In the Matter of Encroachment Permit Application No. L-97-S-1081B

Case No. PH-2020-PUB-10-001

SITE PLAN FOR:
WILSON BANK STABILIZATION
A DEVELOPMENT LOCATED COOLIN, IDAHO

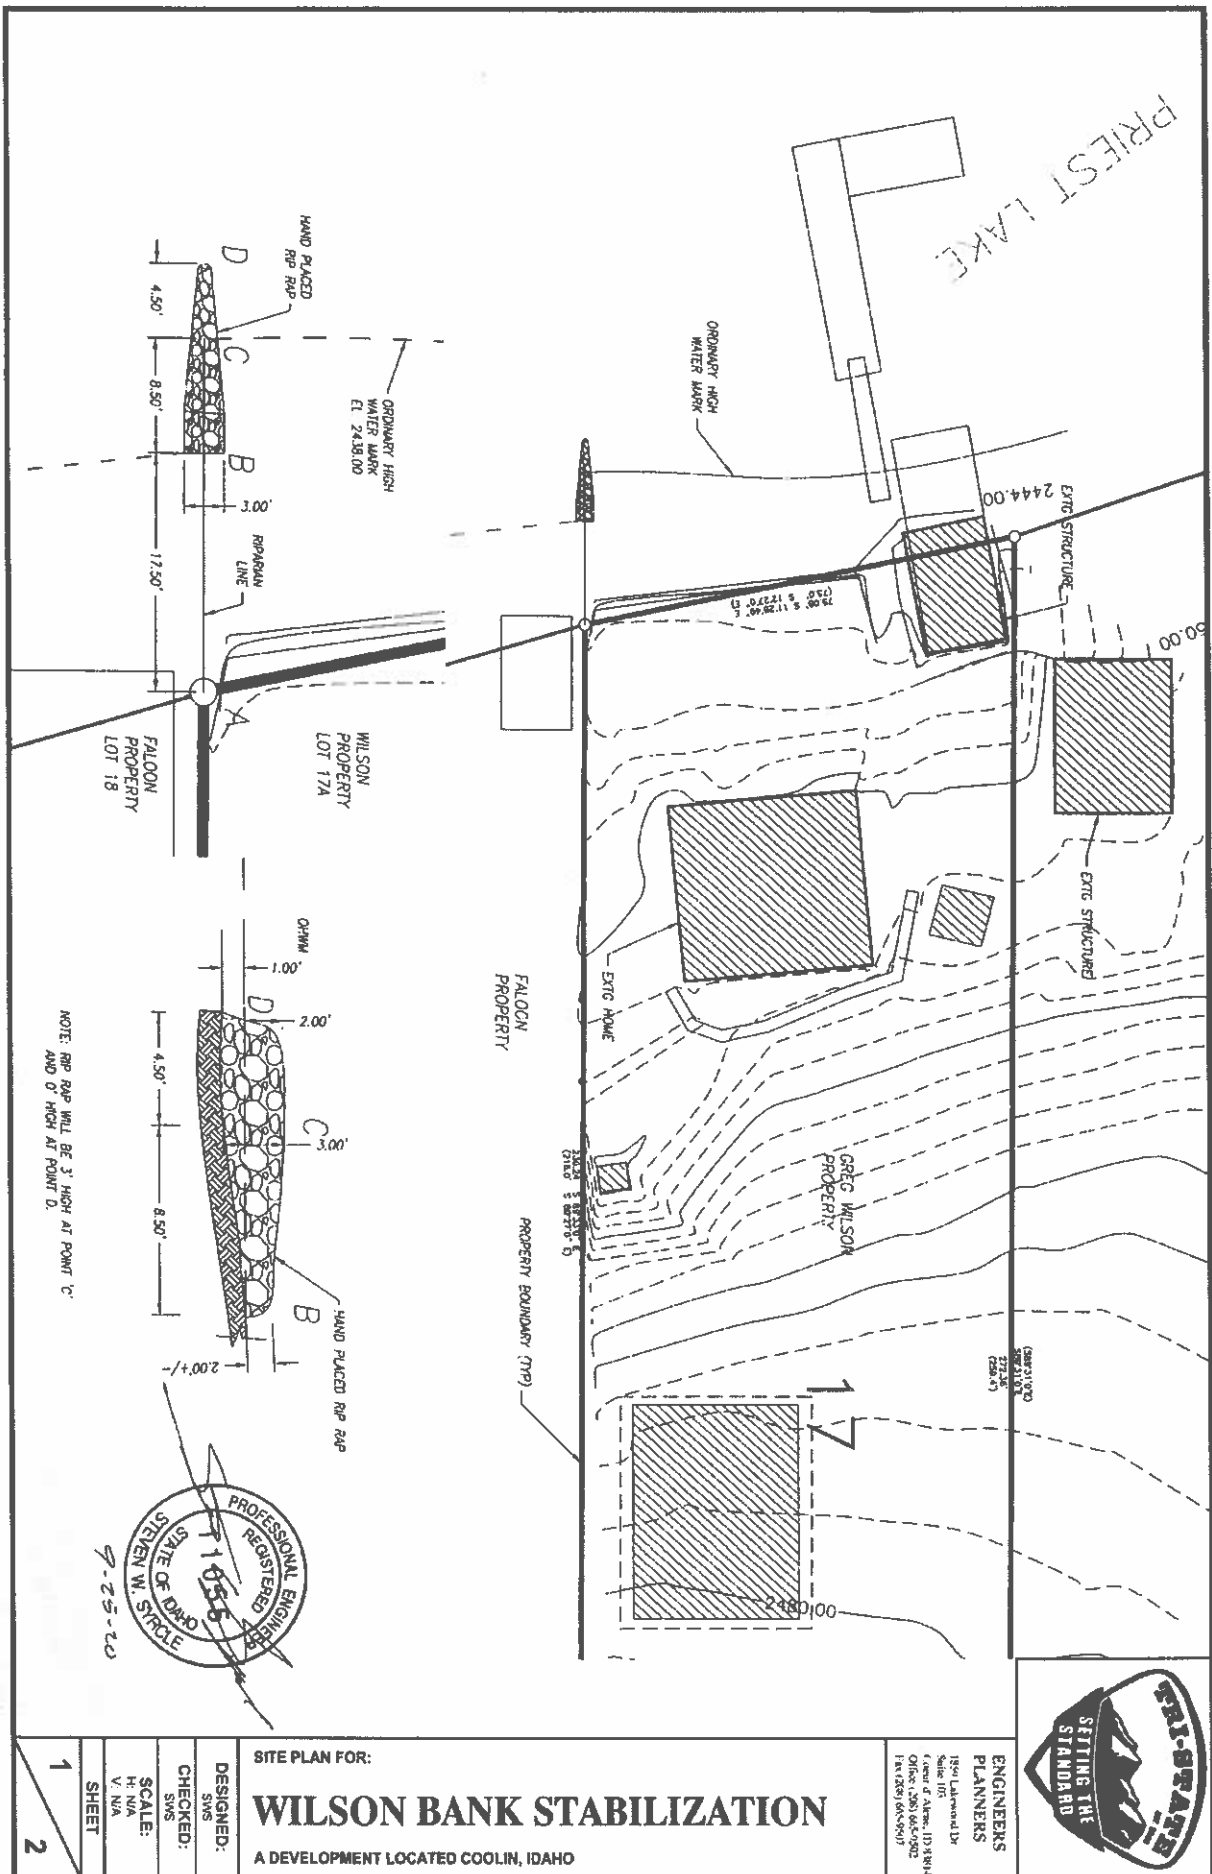
- There is no documentation of regular spring flooding as stated by the Wilsons. The statement that "Each spring the lake floods between 18-36 inches above the 2,438 ft. elevation (Summer pool/OHWM). This seasonal flooding can be erosive on upland beaches" is factually inaccurate and not supported by the USGS records.

- The Wilsons proposed barrier engineering plan is flawed. There are numerous inconsistencies and inaccuracies throughout the plan.
- The Wilsons proposed barrier would, in fact, be larger than what they have already created, which is not permitable.

53 DAYS ABOVE SUMMER POOL

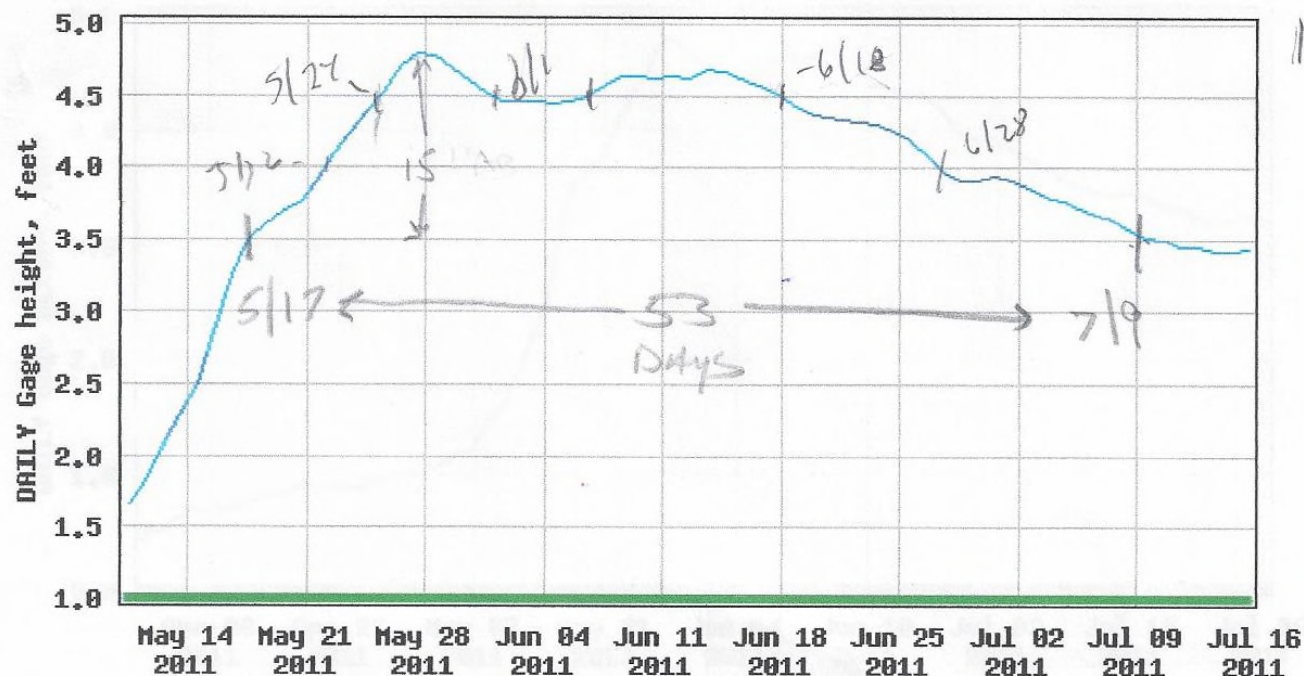
MAX = 15"

12" or higher x 7 days

History of the Encroachment:

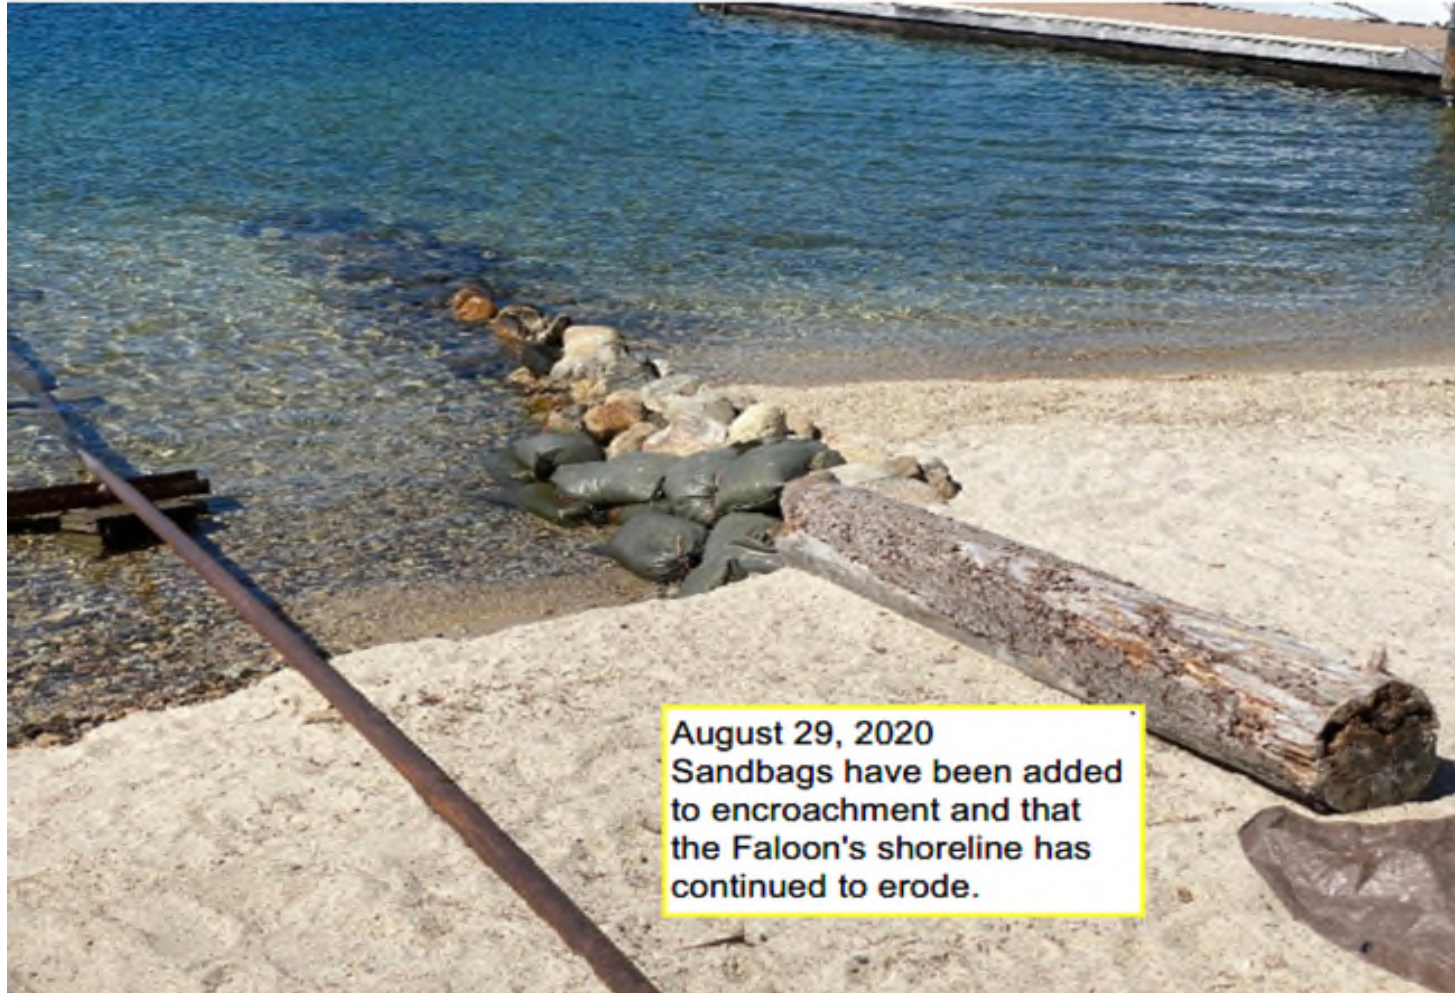
August 29, 2020
Sandbags have been added
to encroachment and that
the Faloon's shoreline has
continued to erode.
